**Virgil C. Summer Nuclear Station Units 2 & 3**

**NND-16-0007**

**SCE&G Response to**

**NRC Request for Additional Information**

**Figure 1**  
**Bounding Containment Temperature Design Envelope for Equipment Qualification for Design Basis Accidents**

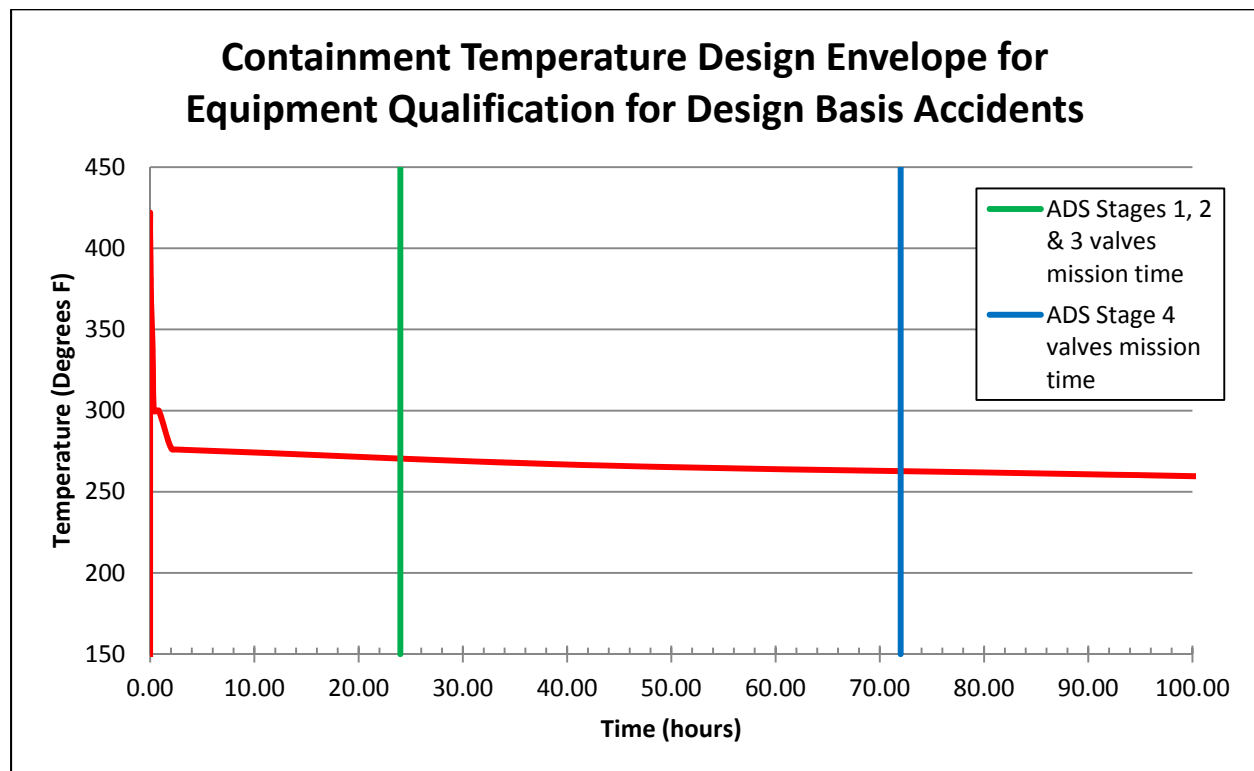
- (1) Provide the spectra over time of the abnormal operating environments inside containment for temperature, pressure, humidity, radiation, chemistry, and submergence based on Table 3D.5-3, and the spectra over time for those environmental conditions determined for the BDBEEs that are the subject of RAI 04-1 (i.e., post-Fukushima lessons learned scenarios), to allow a comparison of the environmental qualification of the ADS established through the AP1000 DCD to the environment conditions that might occur during a post-Fukushima lessons learned scenario.

The mission time for the ADS stage 4 valves is specified to be 72 hours, post-accident. This means that the ADS stage 4 valve qualification profile includes the first 72 hours of the generic AP1000 post-accident temperature and pressure profile from established environmental conditions. Figure 1 shows the bounding Containment Temperature design Envelope for Equipment Qualification for Design Basis Accidents (consistent with Figure 3D.5-8 of the DCD). As mentioned earlier, only the first 72 hours in that profile are applicable to ADS Stage 4. In addition to this post accident qualification, the ADS stage 4 valves are qualified to operate after several abnormal events, categorized into Group 1 and Group 2 events. The Group 1 event profile is established at 150°F for 52 hours, and the Group 2 event profile varies between 250°F and 150°F over the course of 30 days. Figure 2 captures the Temperature profile for Group 1 and Group 2 events (consistent with Table 3D.5-3 of the DCD). Both accident and abnormal environmental conditions for equipment qualification are described in Appendix 3D of the AP1000 DCD.

As a baseline, temperatures used in the evaluation were converted to an equivalent unit durations at 150°F using the Arrhenius model. After using the Arrhenius model to establish a ratio of times for a given temperature, the two profiles shown in Figure 1 were evaluated to determine a single value for each profile. The single value represents the integrated time spent at 150°F to replicate the thermal effects of that particular profile. Results were achieved using trapezoidal methods of numerical integration for equivalent 150°F data and are summarized in Table 1.
